Access Compliance Report

Public Rights-of-Way

Intersection ID: 11942	Main Street: COUNTRY CLUB LN	Cross Street: MATHESON AV	Location: NE
ADA ID: DB0E985422B2	Ramp Type: Perp	Initial Pass/Fail: Fail	Overall Compliance: No
		Severity Score: 8.75

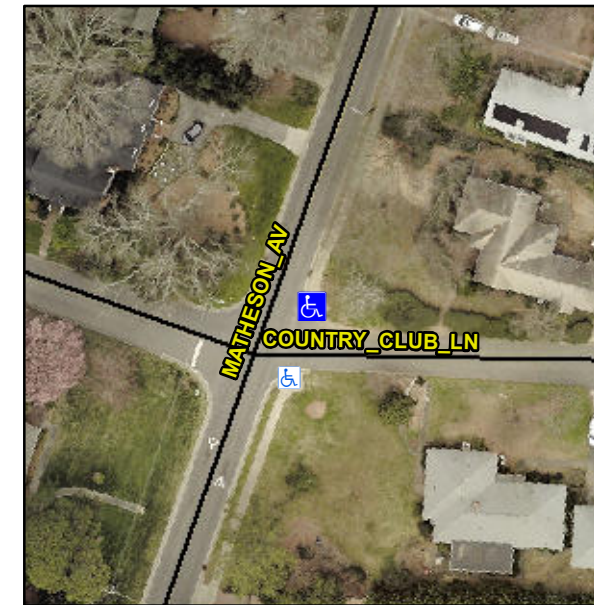
Not Found, R304.5.1

Compliance	Description	Data	Compliance	Description	Data
N/A	Ramp Length (in)	71.0	Yes	Ramp Slope (%)	7.4
No	Ramp Width (in)	38.0	Yes	Ramp XSlope (%)	1.5
N/A	Flare Type LT	N/A	N/A	Flare Type RT	N/A
N/A	Flare Slope LT (%)	N/A	N/A	Flare Slope RT (%)	N/A
N/A	Flare Traversable LT?	N/A	N/A	Flare Traversable RT?	N/A
N/A	Landing Length (in)	N/A	N/A	DWS Provided?	N/A
N/A	Landing Width (in)	N/A	N/A	DWS Contrast?	N/A
N/A	Landing Slope (%)	N/A	N/A	DWS Length (in)	N/A
N/A	Landing X Slope (%)	N/A	N/A	DWS Full Width?	N/A
N/A	Landing Curb? (Y/N)	N/A	N/A	DWS Offset (in)	N/A
N/A	Shared Landing?	N/A			
N/A	Gutter Ponding?	Yes	N/A	Gutter Slope (%)	N/A
N/A	Gutter Lip Ht (in)	N/A	N/A	Gutter X Slope (%)	N/A
N/A	Painted X Walk1?	No	N/A	Painted X Walk2?	N/A
	X Walk 1 Direction	To SW		X Walk 2 Direction	N/A
N/A	X Walk 1 Width (in)	N/A	N/A	X Walk 2 Width (in)	N/A
	X Walk 1 Slope (%)	2.8		X Walk 2 Slope (%)	N/A
	X Walk 1 X Slope (%)	0.6		X Walk 2 X Slope (%)	N/A

Remove & Replace Entire Ramp.
